NuLu Review Overlay District (NROD)

Report to the Committee

Case No: 24-OVERLAY-0042

This application requests approval for the construction of an open air pedway, providing a pedestrian connection between two buildings at NuLu Marketplace: NuLu Marketplace South (815 E Market) and NuLu Marketplace Phase 2 (to be constructed on four parcels along E Main). The pedway will be constructed on the rear facades of each building, connecting them at the second story level, and crossing over Billy Goat Strut.

Rear (East) Rendering – Billy Goat Strut

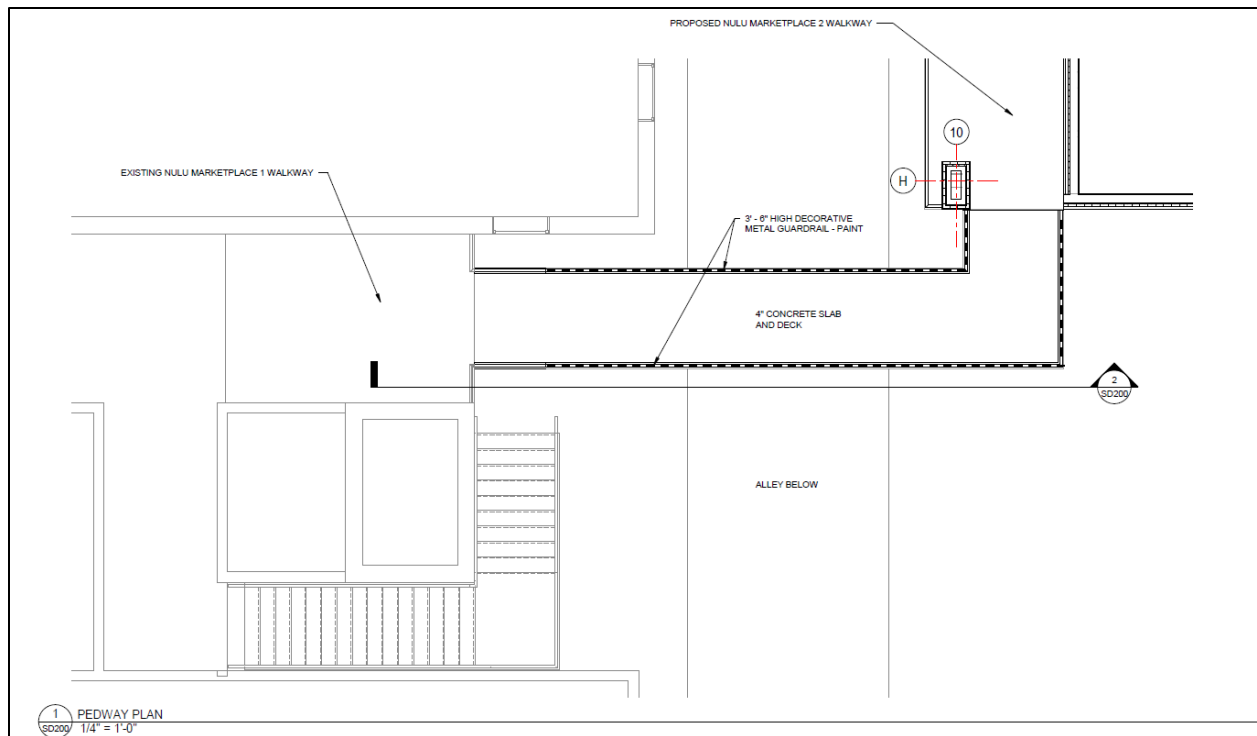
The pedway meets the applicable design guidelines for NROD. It will be located on the rear of the buildings and will not be highly visible from a public street. The scale and materials used are complimentary to the existing and soon to be built NuLu Marketplace buildings.

Overall, the pedway has the opportunity to create a more dynamic, visibly interesting alley space. Staff recommends utilizing lighting or public art along the bottom of the decking for safety and to further enhance the structure and activate the alley.

1. **All other required approvals, including reviews and permitting through Public Works, shall be obtained prior to construction.**
2. **Intensity, location, color, and direction of outdoor lighting shall be sensitive to nearby residential areas.**
3. **There shall be adequate and appropriate lighting under the deck of the pedway to ensure the safety of motorists and pedestrians on the alley passing beneath the pedway. When open to use, there shall also be adequate lighting atop the pedway to ensure the safety of pedestrians utilizing it. Staff encourages the use of artistic lighting effects to help activate the alley and create a more interesting space. Final lighting details shall be provided to staff for review and approval prior to installation.**
4. **If the design or materials change, the applicant shall contact staff for additional review and approval.**
